UNITED STATES PATENT AND TRADEMARK OFFICE

APPLICATION NO.	FILING DATE	FIRST NAMED INVENTOR	ATTORNEY DOCKET NO.	CONFIRMATION NO.
10/078,601	02/19/2002	Xiaoming Ren	107044-0013	5541
24267	7590	02/18/2004	EXAMINER	
CESARI AND MCKENNA, LLP 88 BLACK FALCON AVENUE BOSTON, MA 02210			ALEJANDRO, RAYMOND	
			ART UNIT	PAPER NUMBER

Office Action Summary

DETAILED ACTION

FIG. 5

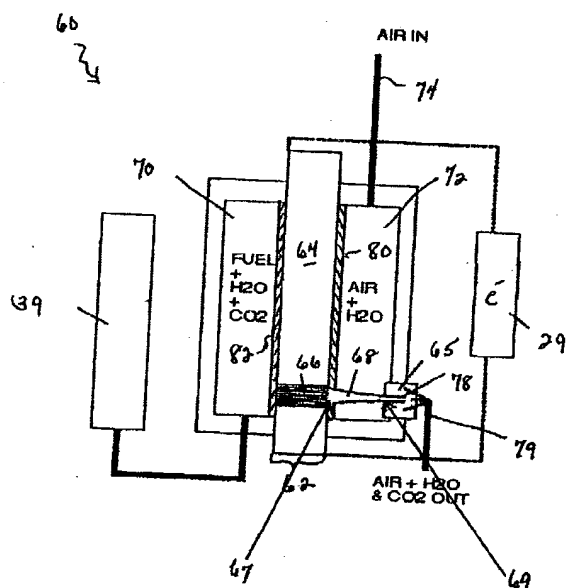
Figure 5 below depicts a passive control system using gas produced in the anode chamber for removing water from the reactive sites in the cathode chamber (SECTION 0085).

As apparent from Figure 5 and Corey et al's disclosure of SECTIONS 0014, 0017 and 0020), this fuel cell system: i) can be provided with a gaseous effluent port located in the anode chamber in close proximity to the anode side of the membrane electrolyte; and ii) does not have any liquid exit port in the anode chamber per se. Thus, it has a liquid closed volume anode chamber, and no anode liquid recirculation. These features act as a gaseous anodic product removal component. This structure also encompasses the absence of any water external pumping and/or active water removal element.

As previously mentioned, the fuel cell system of **Figure 5** above represents a passive fuel cell system (SECTION 0085). Thus, it operates without external pumping of cathodically-generated water and without active water removal elements.

As apparent from Figure 5 and Corey et al's disclosure of SECTIONS 0014, 0017 and 0020 and 0026, this fuel cell system: i) can be provided with a gaseous effluent port located in the anode chamber in close proximity to the anode side of the membrane electrolyte; and ii) does not have any liquid exit port in the anode chamber per se. Thus, it does have a liquid closed volume anode chamber, and no anode liquid recirculation.
